DOCKETED
09-AFC-7C

**RE: PALEN SOLAR PROJECT AMENDMENT (09-AFC-7C)
DATA REQUEST SET 2 (Nos. 19–39)**

**PALEN SOLAR POWER PROJECT (09-AFC-7C)
DATA REQUESTS – SET 2**

CULTURAL RESOURCES - FIGURE 1
Palen Solar Electric Generating System - Initial Staff Project Area of Analysis (PAA)

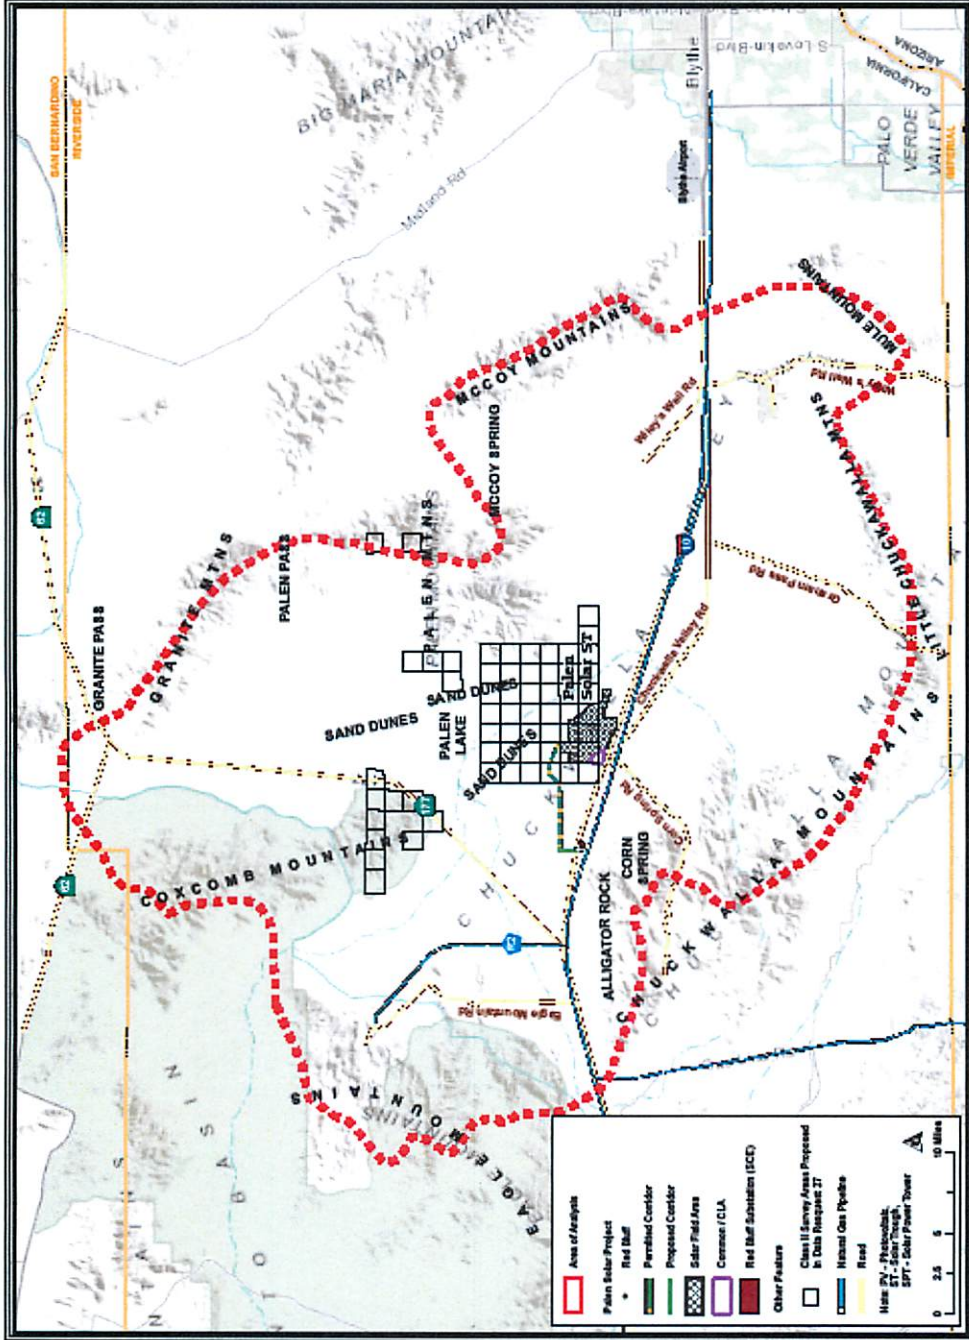
21. Staff has sketched out, in relatively broad strokes, a preliminary concept of what staff believes is the appropriate PAA for the proposed project. Please refine the concept that staff has set out, both above and below, adjust it on the basis of explicit argumentation, and plot out the boundaries of the project owner's iteration of the resultant PAA on a map of no less than a 1:24,000 scale. The project owner's iteration should include a delineation of the original project boundary and the new project boundary. Those areas from which the power towers will not be visible may be eliminated from the approximate 15-mile radius depicted in Figure 1. Please provide explicit justifications to support areas eliminated in this manner. The PAA is and will remain the fundamental basis for all subsequent requests for information related to the potential effects of the amended project on cultural resources. Staff's preliminary reiteration of it here is the foundation for the present cultural resources data requests. If the project owner's concept of the PAA differs significantly from staff's, staff would encourage the project owner to notify staff and, at the earliest possible date, seek to publicly resolve any substantive differences of opinion.
